CRR Future Credit Exposure Weighting Factors

DC Energy Comments

CRR FCE Weighting Factors – Executive Summary –

Company X's November 2006 6-month Portfolio – FCE under ERCOT Initial Proposal and DCE Proposal –

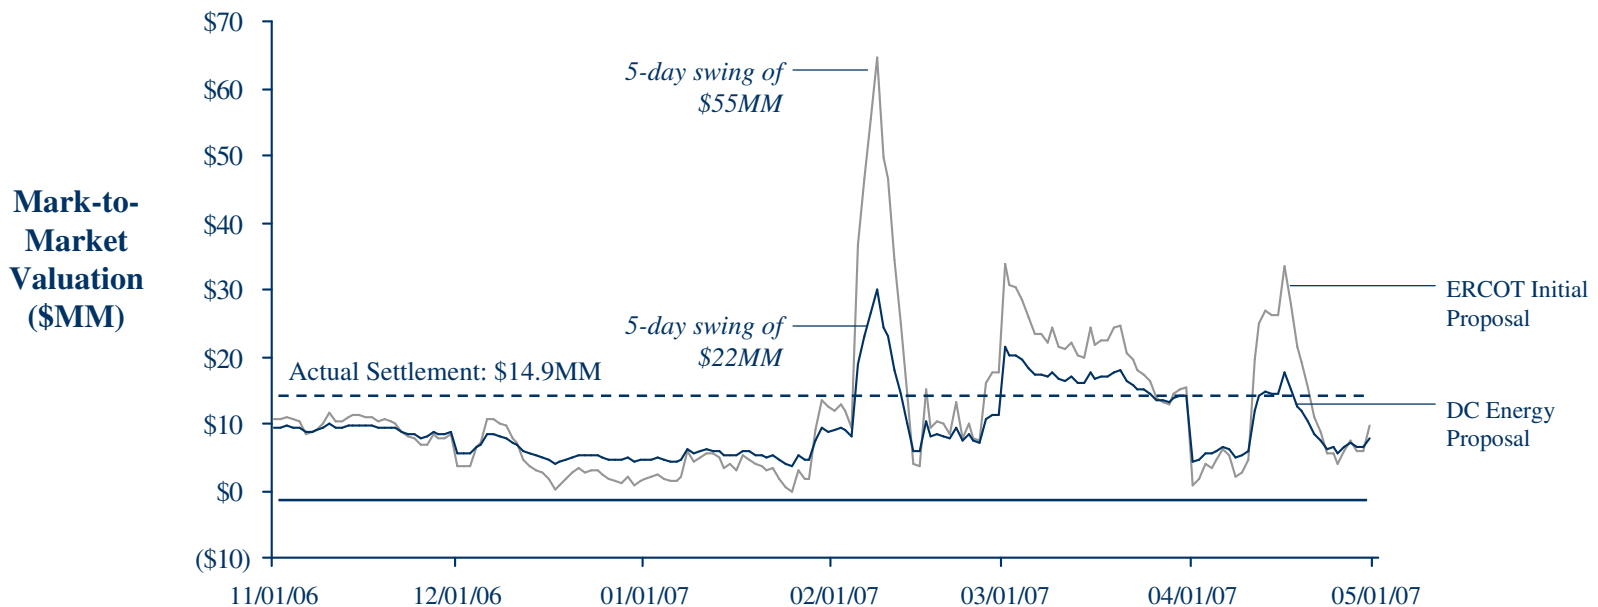
DC Energy's proposal for weights takes into account the impact of longer term averages on potential credit exposure.

DC Energy's proposed weights reduces the short term mark-to-market valuation during short term price spike events to modest levels

Today	Five Day	Last Month	ACP
CM, CM+1	10%	20%	45%	25%
CM+2 & beyond	4%	8%	20%	68%

NYISO November 2006 6-Month Auction – Mark-to-Market Valuation Standard Deviation –

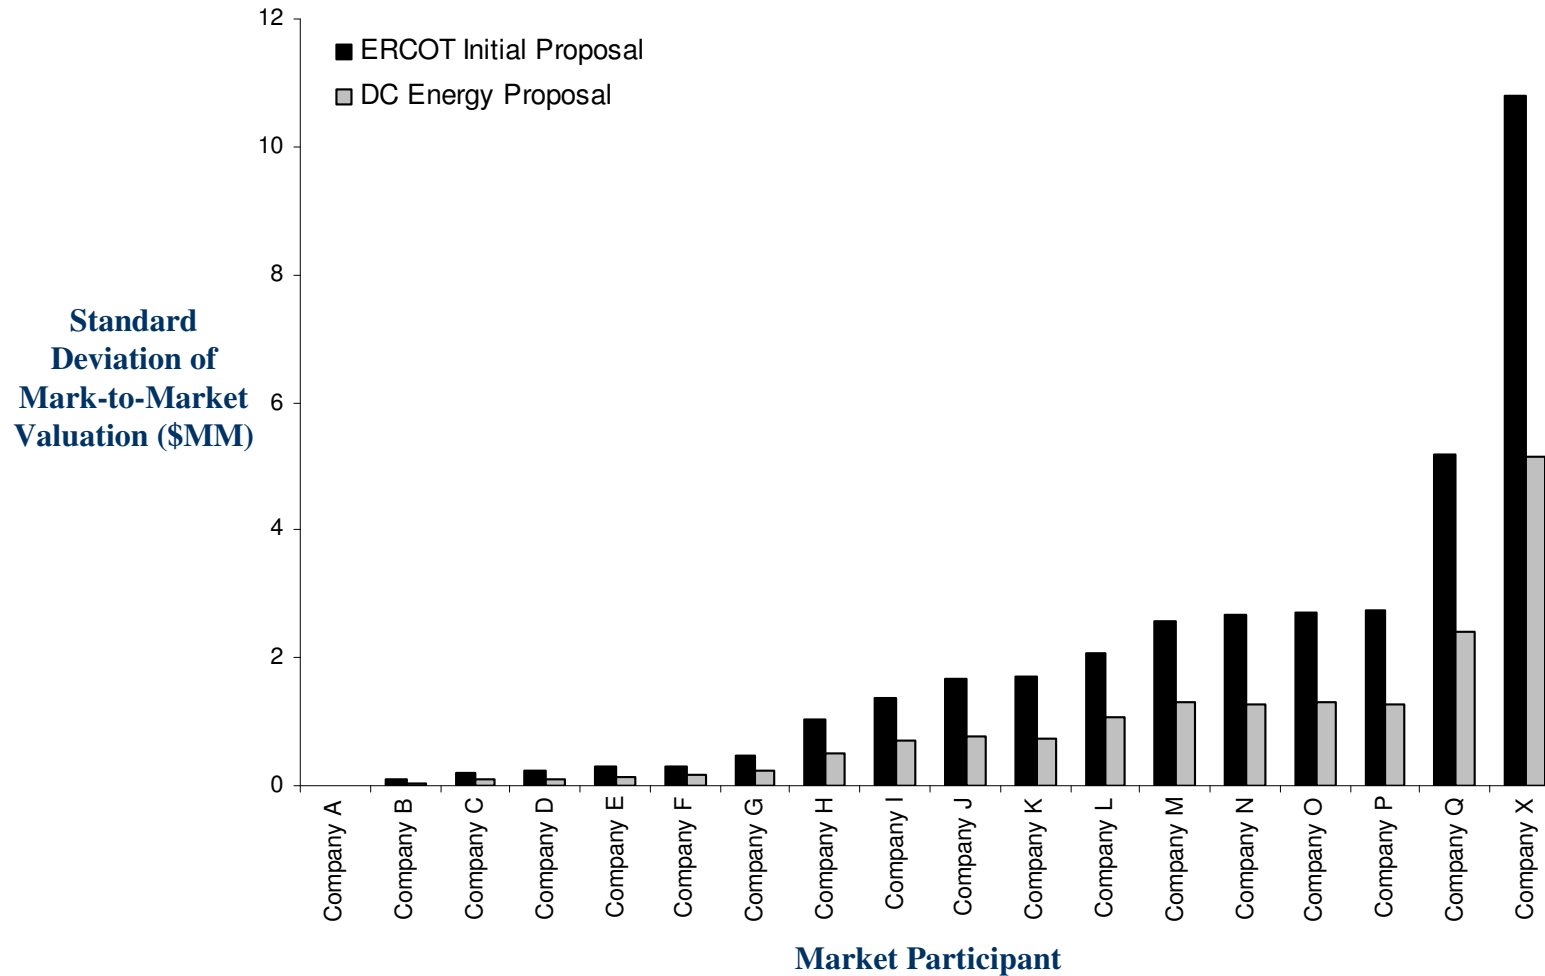
DC Energy's proposal for weights significantly reduces the volatility of the mark-to-market valuation at the portfolio level

NYISO November 2006 6-Month Auction – FCE Under-Collateralization, Negative Portfolios –

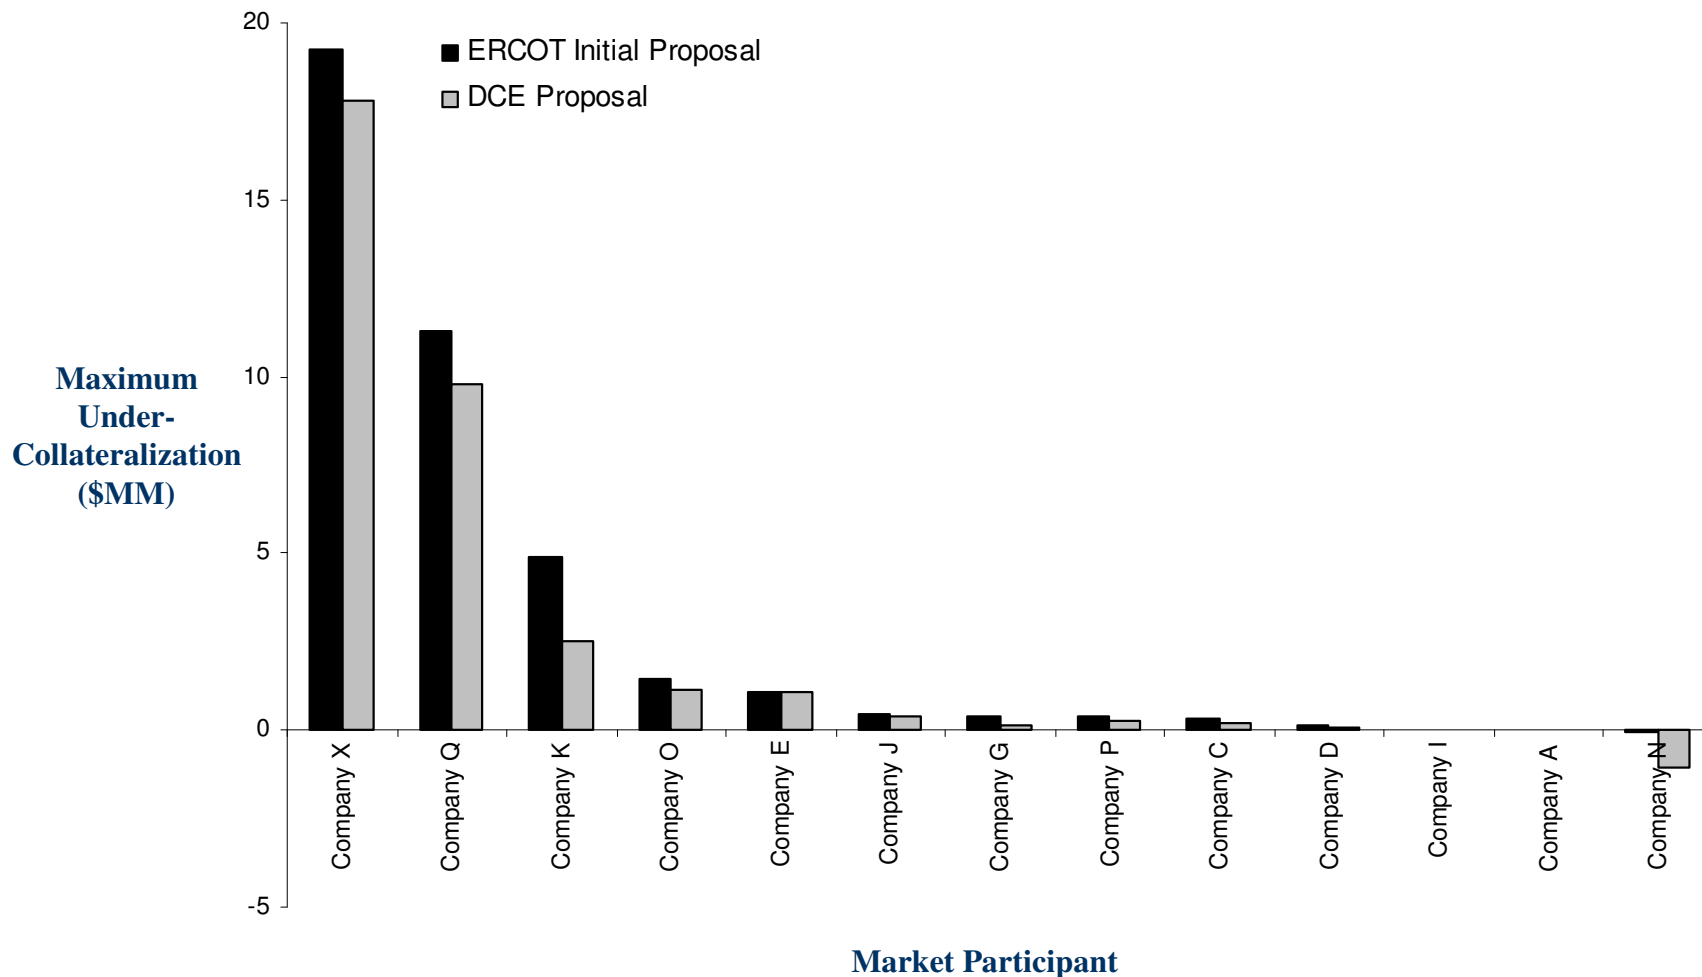
DC Energy's proposal for weights in all cases has lower maximum under-collateralization for the negatively priced portfolios of market participants
